Packet Guide

B. Consent Agenda

On July 17, 2018, the BAR approved the following CoA application.

Door specification 3rd page

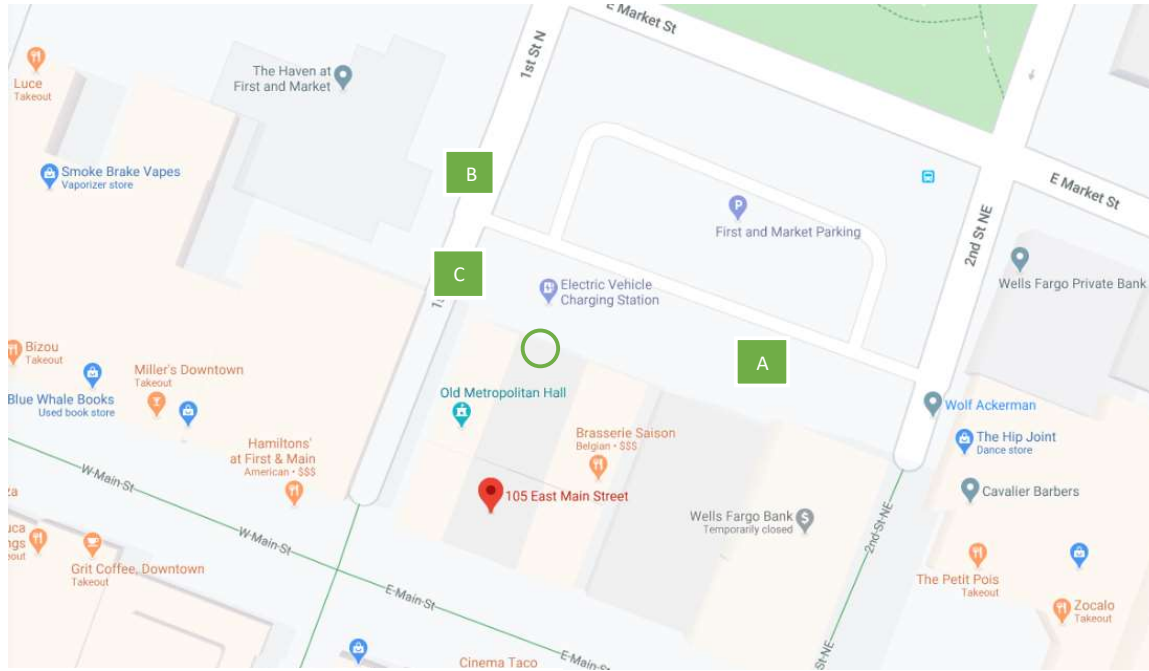
Request to remove the existing window and metal grate and install into the opening a new entry door with side lite.

- Retain and store the existing window and metal grate, should the opening be later restored.
- The existing masonry opening—width, height and arch--is not altered other than below the existing window.
- Provide cut sheets of the proposed door, side lite, frame, and hardware.

- Applicant to retain and store the existing window and metal grate, should the opening be later restored.
- The existing masonry opening—width, height and arch--is not altered other than below the existing window.
- Provide to staff for the BAR archives cut sheets on the proposed door, side lite, frame, and hardware.

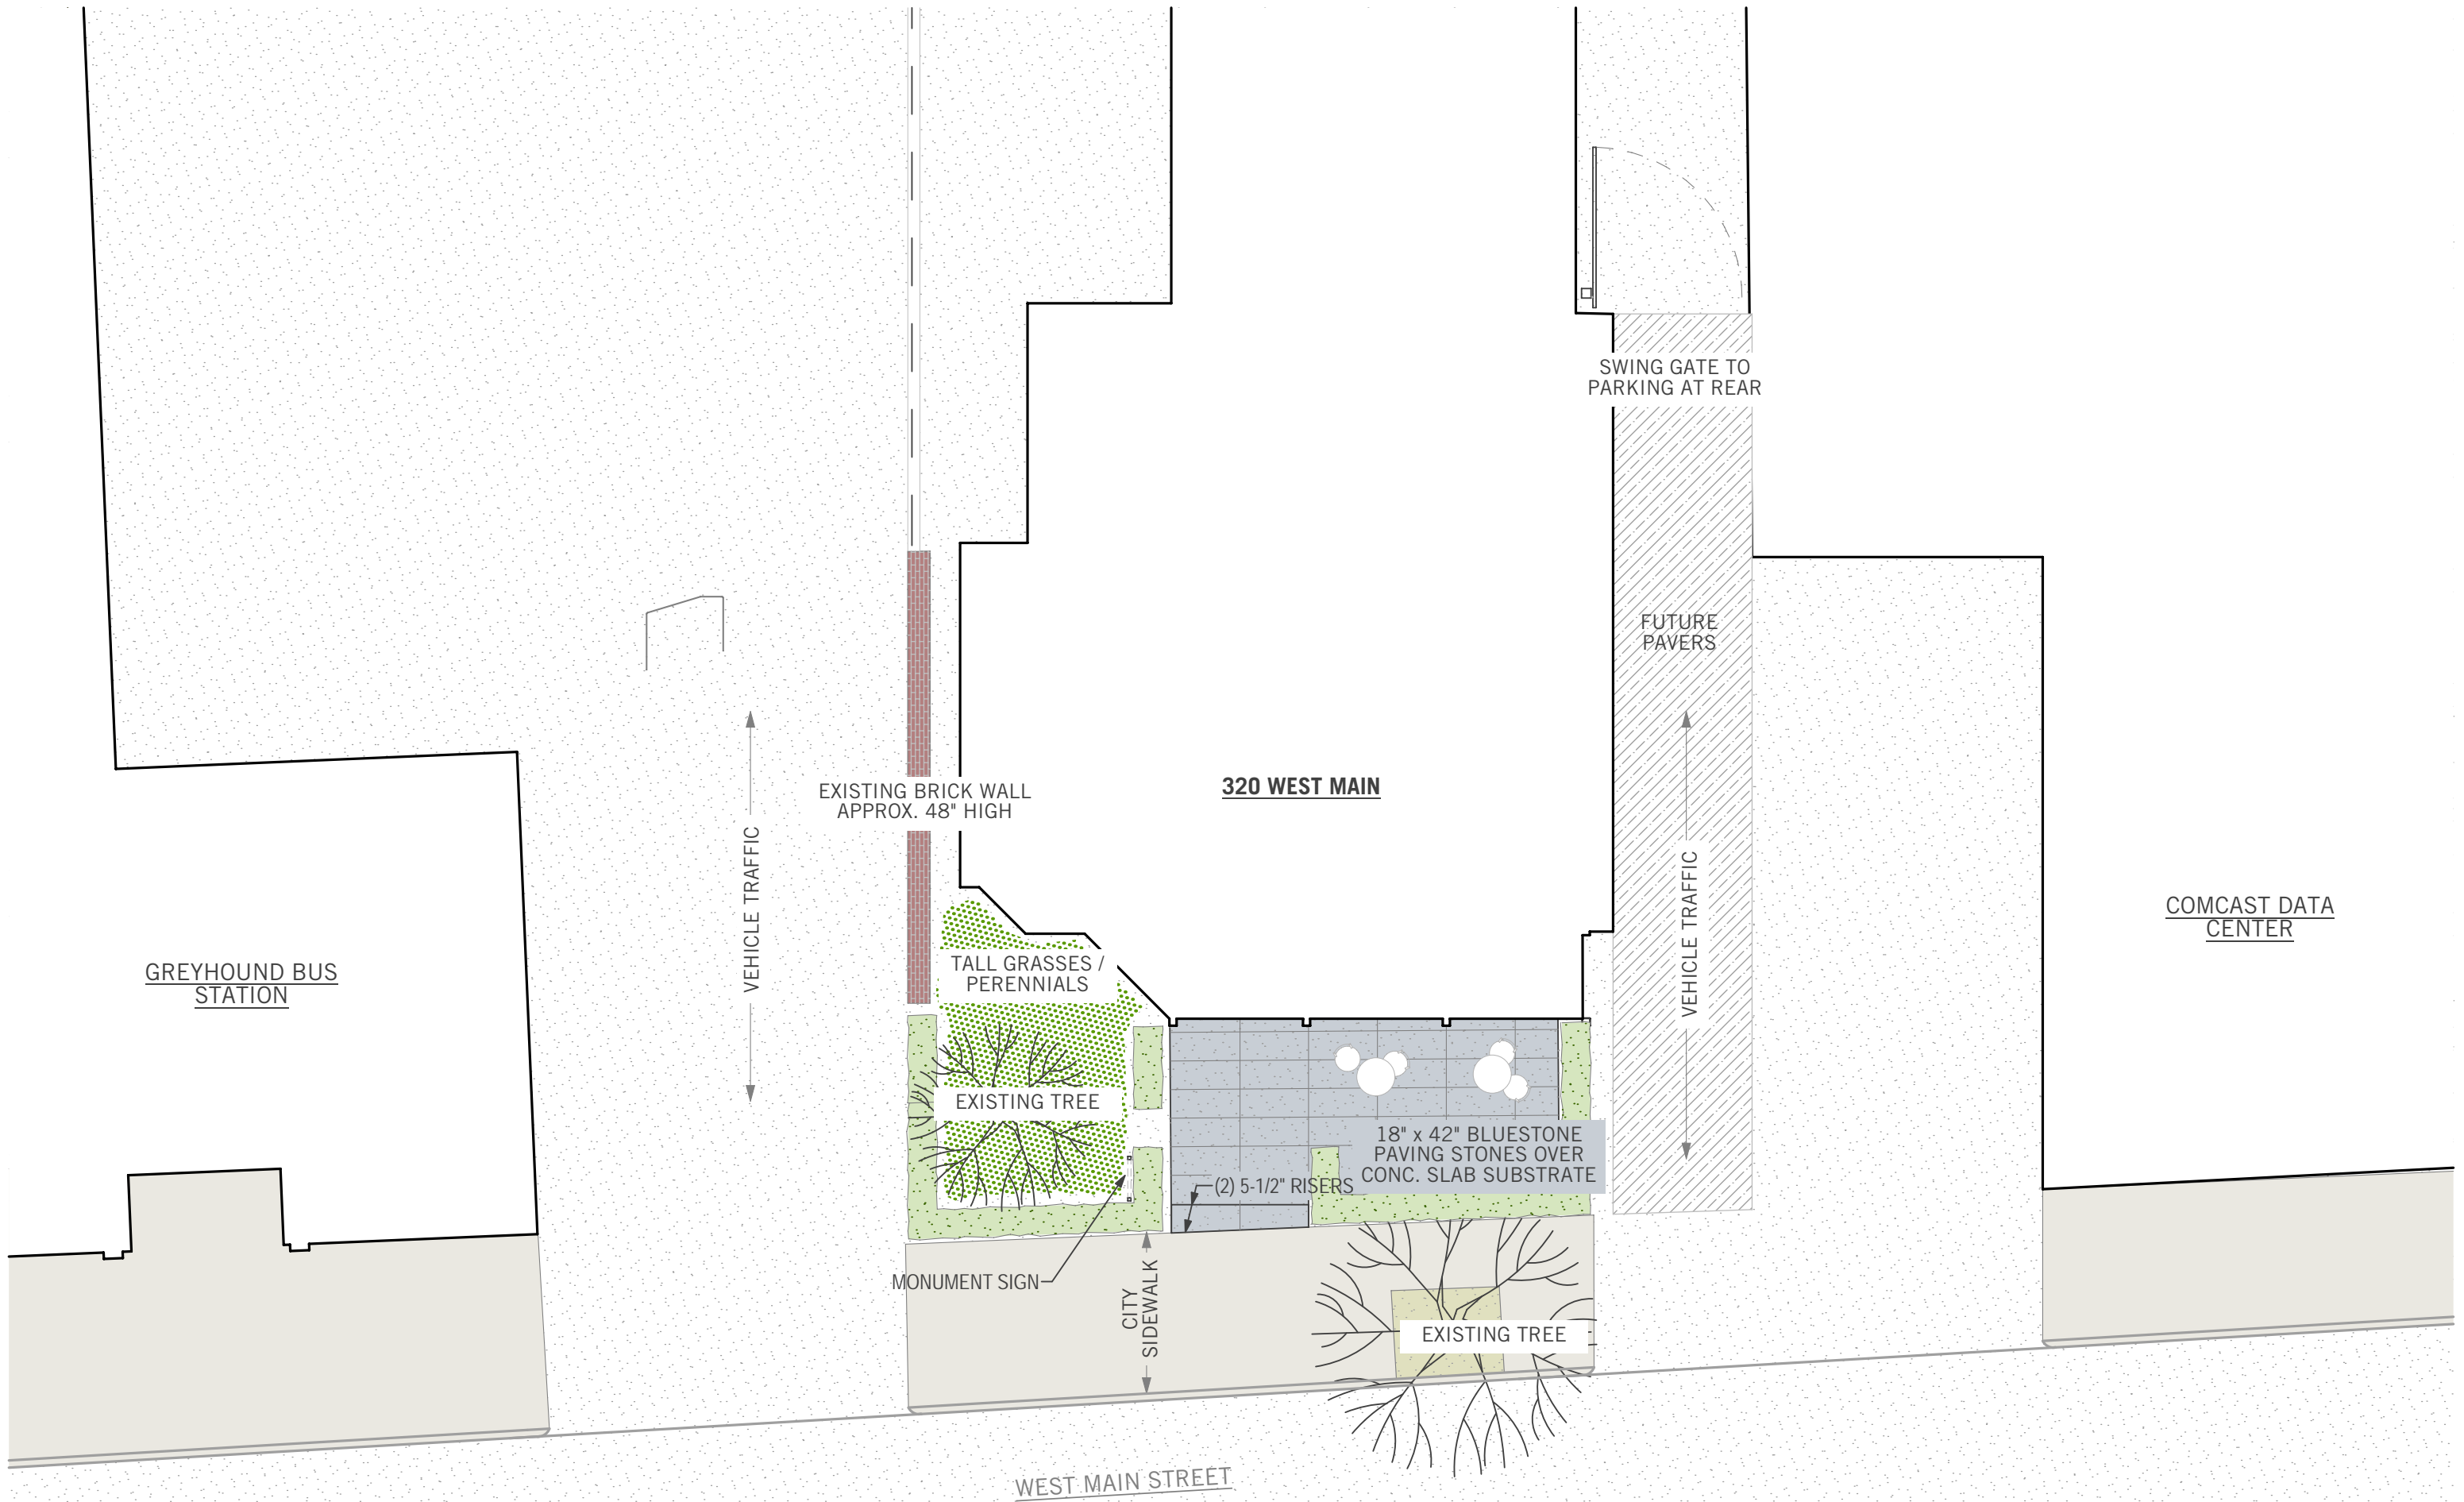
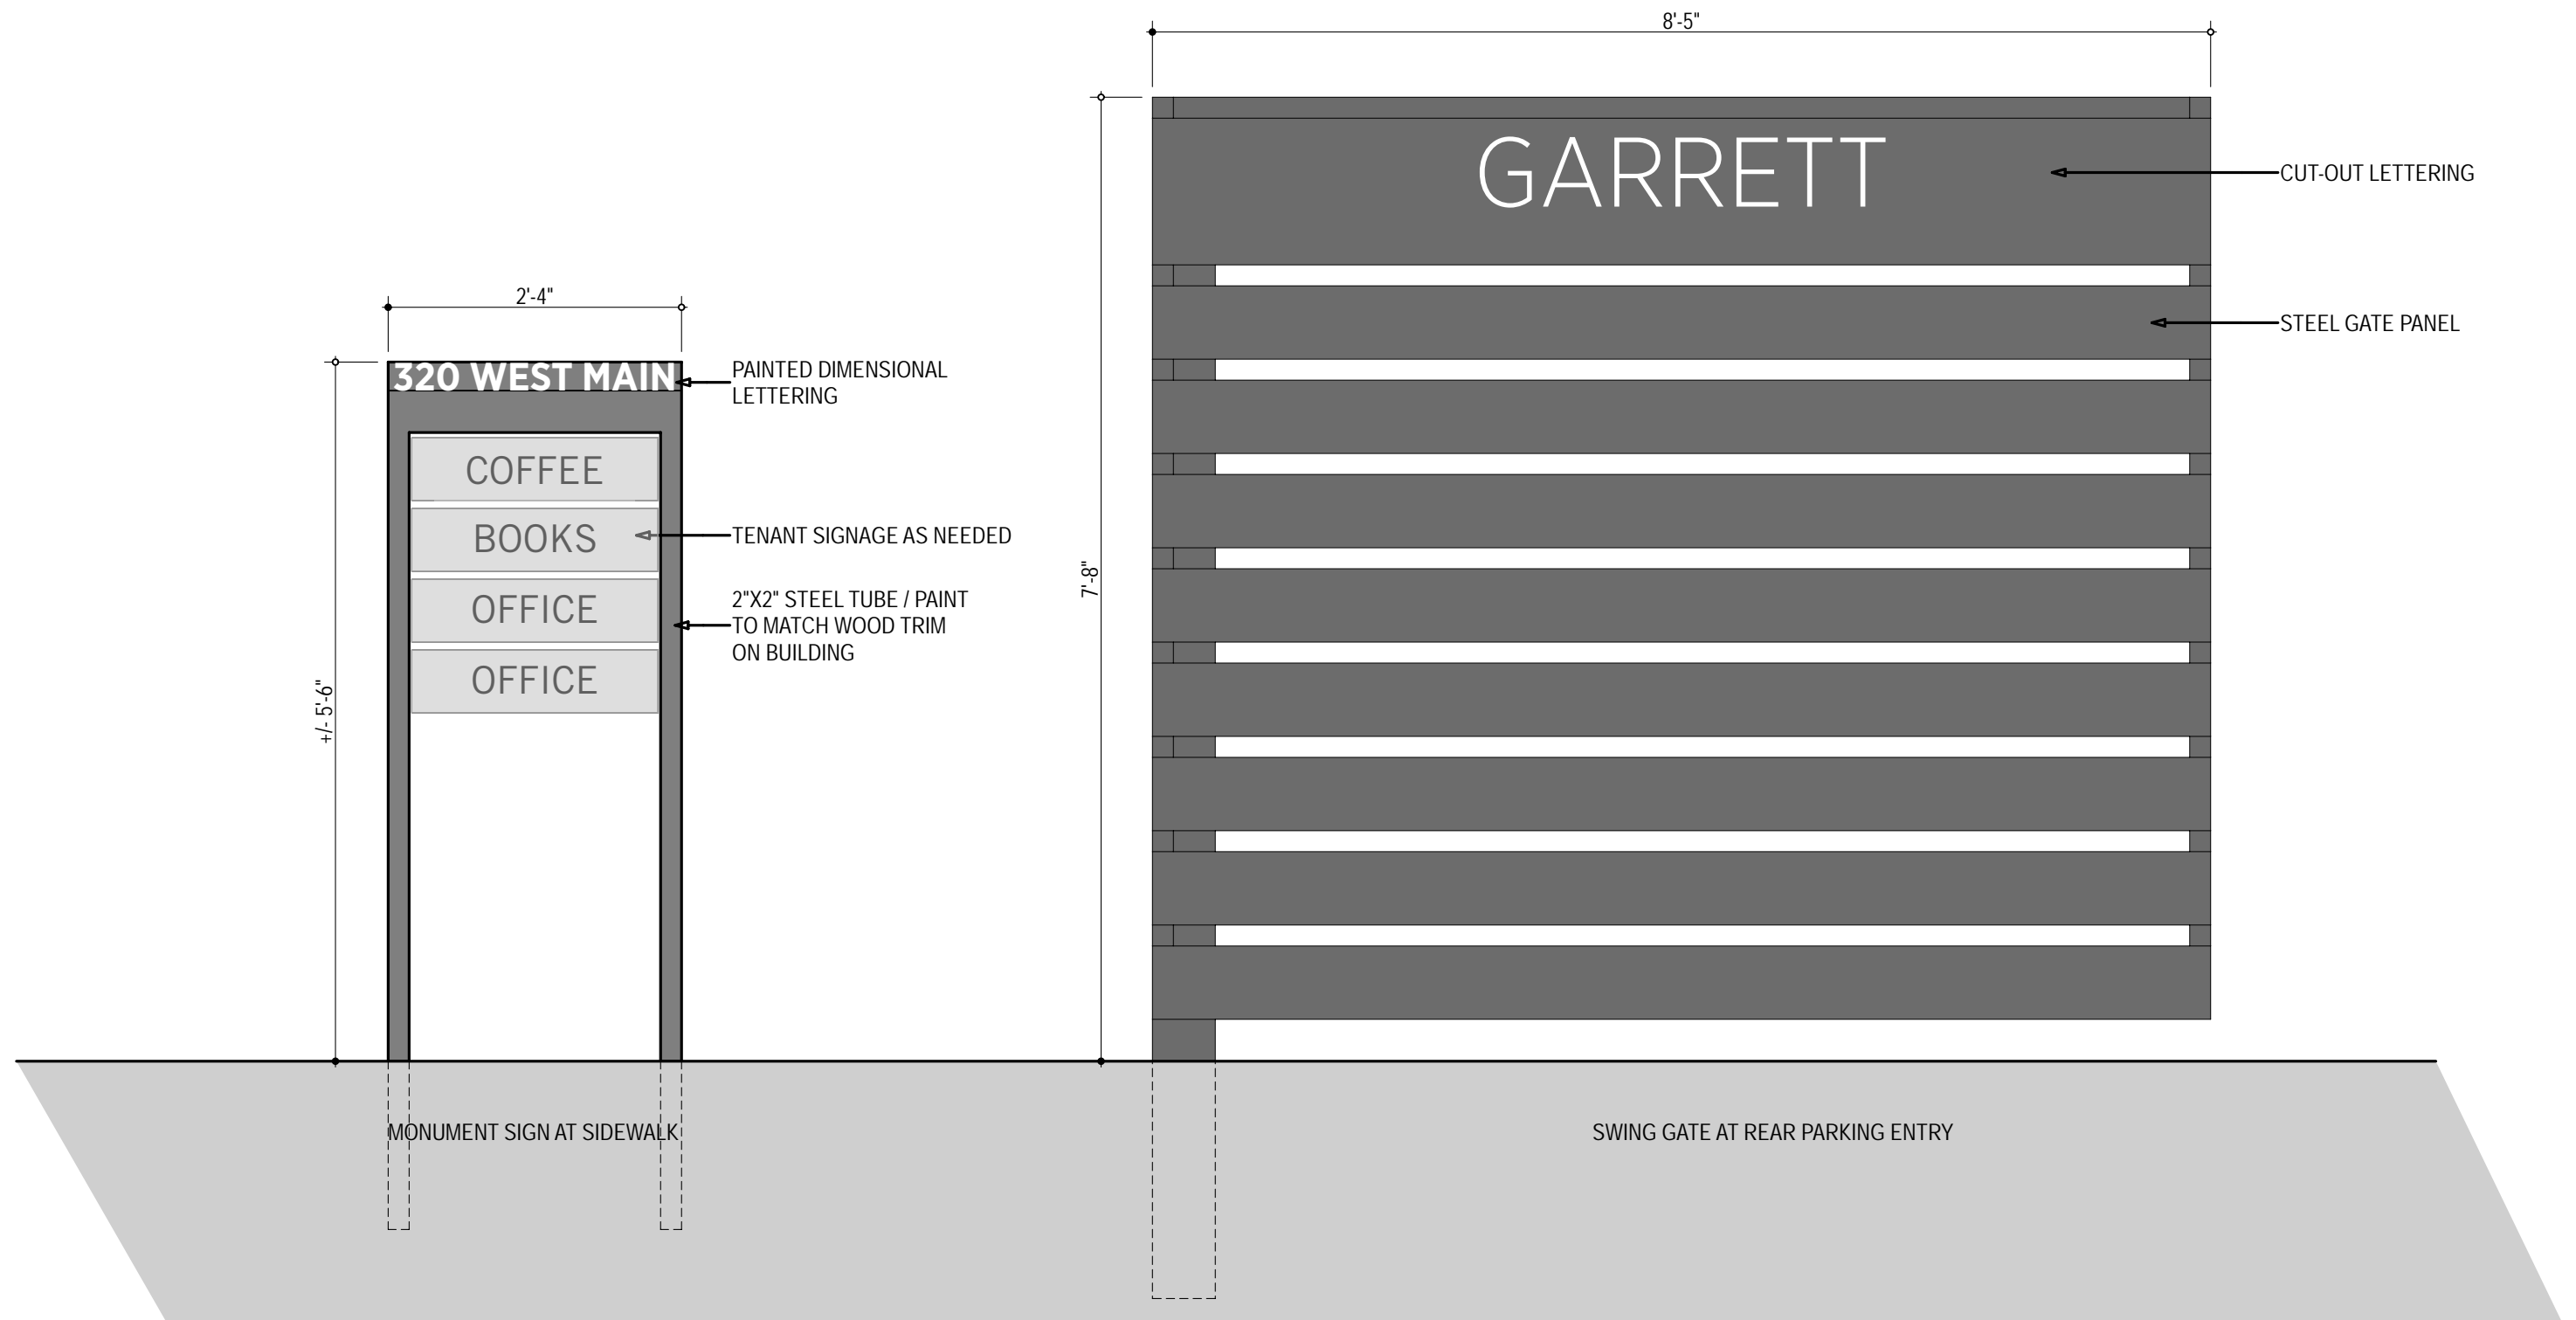
- Remove vertical siding, aluminum storefront, and windows at front porch enclosure (non-historic).
- Remove fabric canopy.

- Remove six double-hung windows (two at the first floor bay, three at second floor) and replace with Marvin double-hung windows with two-over-two lite configuration (per historic photographs).

- Remove metal railing at entry and install new.
- At west side of structure, install steel swing-gate with cutout signage at top.
- At the sidewalk, install a monument sign.
- At entry terrace, install 18" x 42" bluestone pavers over concrete slab.

Removing an outdated and inappropriate enclosure of the front porch. Ideally, it would be left open, but the proposed is an improvement and does not remove or conceal historic elements.

- Applicant will provide to staff for the BAR archive cut sheets for the doors, windows, and any exterior light fixtures.
